PRODUCT BULLETIN

Bulletin No: PB408
Issue Date: 9-28-2017
Effective Date: 9-28-2017

Description/Title:
Debris Screen for HAKKO FA-430 Duct Kit Nozzles

Part No:
999-700

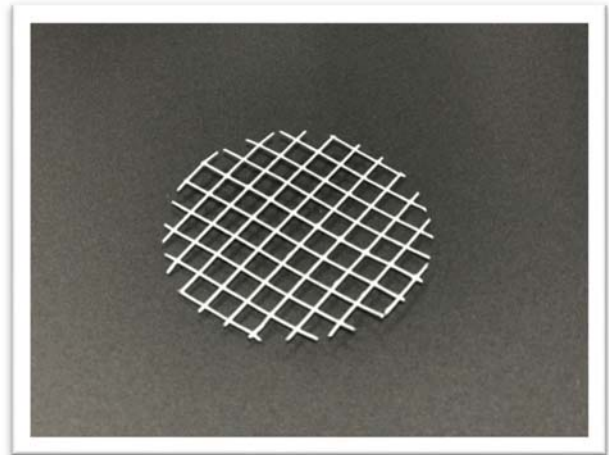
This new improved debris screen is made from a durable steel wire and has a longer service life compared to the standard netting (PN: B3625) that comes with the HAKKO FA-430 Duct Kits (PNs: C1571 and C1572).

The debris screen is easy to install inside the nozzle and does not affect the filtration performance of the HAKKO FA-430 Fume Extraction System.
